Re: Application for Comprehensive Permit, The Sanctuary, School Street, Manchester, MA

On behalf of the Manchester Essex Conservation Trust ("METC"), I am writing to provide comments on the hydrologic impacts of the proposed "Sanctuary" project on the certified vernal pools.

Figure 3 - Watershed Overlay on Drainage Design

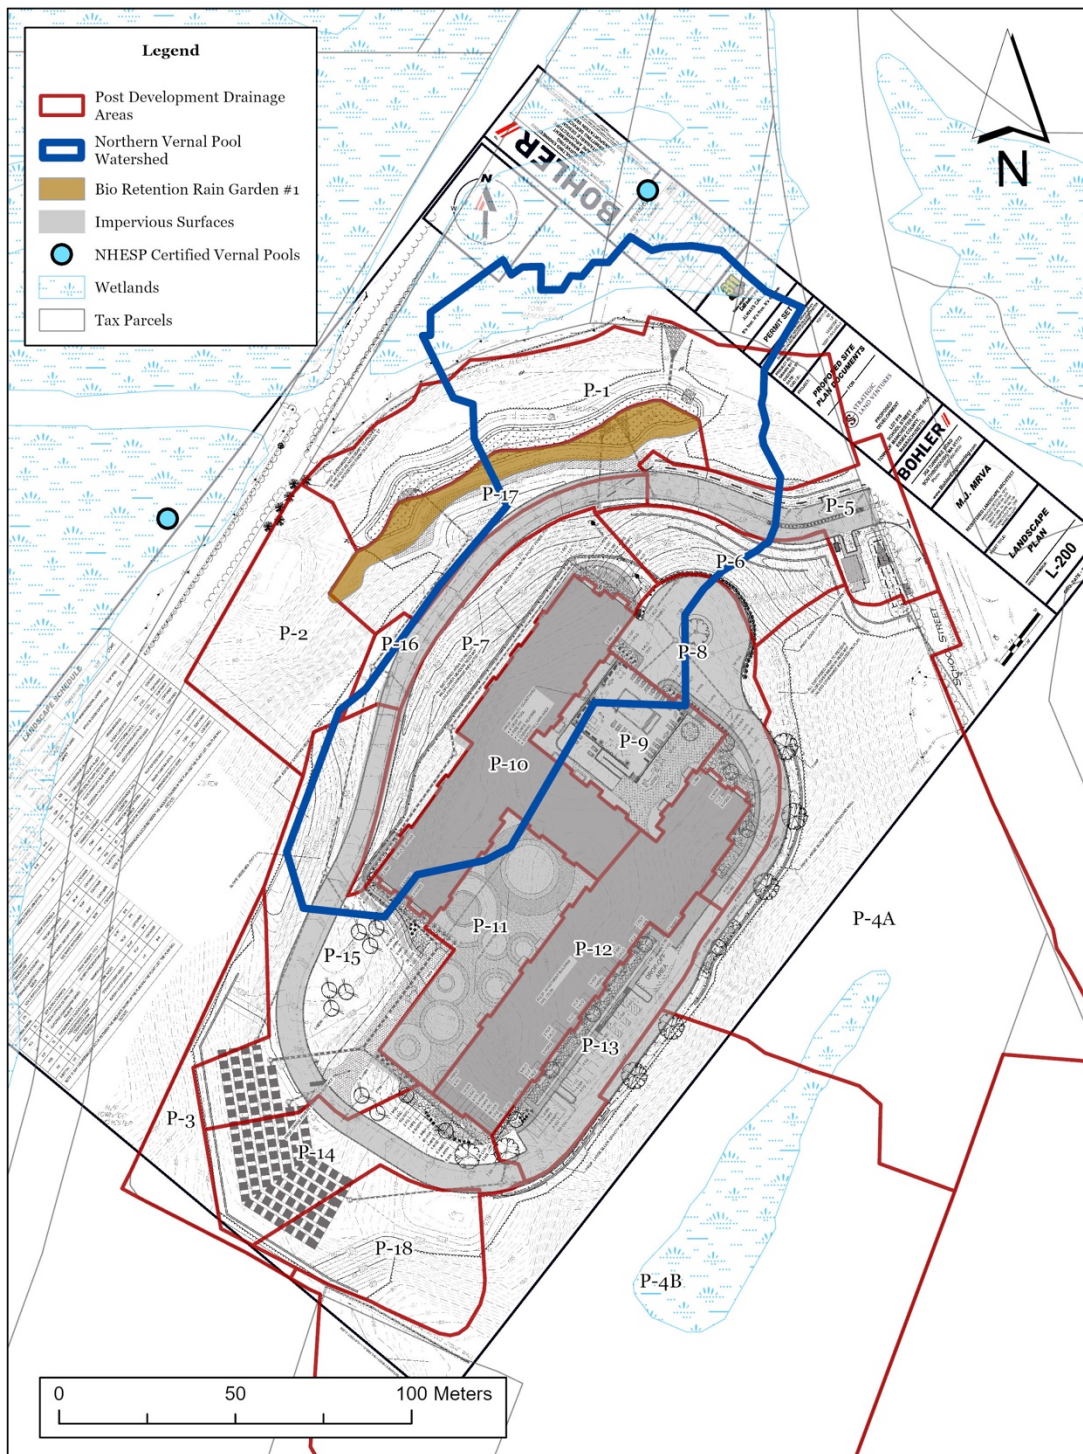
To evaluate post-development conditions, GIS assistance was provided by the Manchester-Essex Conservation Trust (MECT). The northern vernal pool watershed map was overlaid on the Applicant's Post-Development, "Proposed Watershed Plan PWS-1", prepared by Allen & Major and included in the Drainage Report dated May 8, 2022 (see figure 3).

Post development, the majority of the proposed impervious areas within the existing vernal pool watershed will be routed outside of the vernal pool watershed to the two underground

infiltration systems (shown within the P-14 and P-18 subcatchments on the plan). This system is designed to infiltrate the majority of annual runoff from the contributing impervious surfaces at these locations (outside of the vernal pool watershed). This represents a significant transfer of water outside of the hydrologic budget of the vernal pool.

The drainage from the proposed impervious areas (P-5 and P-6) are also routed outside of the vernal pool watershed to Bio-Retention Area/Rain Garden #2 located near the entrance on School Street. A smaller portion of the impervious area within the vernal pool watershed is routed to Bio-Retention/Rain Garden #1. However only about half of this rain garden is within the vernal pool watershed.

The post-development hydrologic budget is shown in Table 2. This analysis indicates that significant reductions in groundwater recharge of 40 – 50% will result from the proposed development during the critical Spring season. This will result in lowered water levels and impairment of the wildlife habitat conditions in the northern vernal pool.
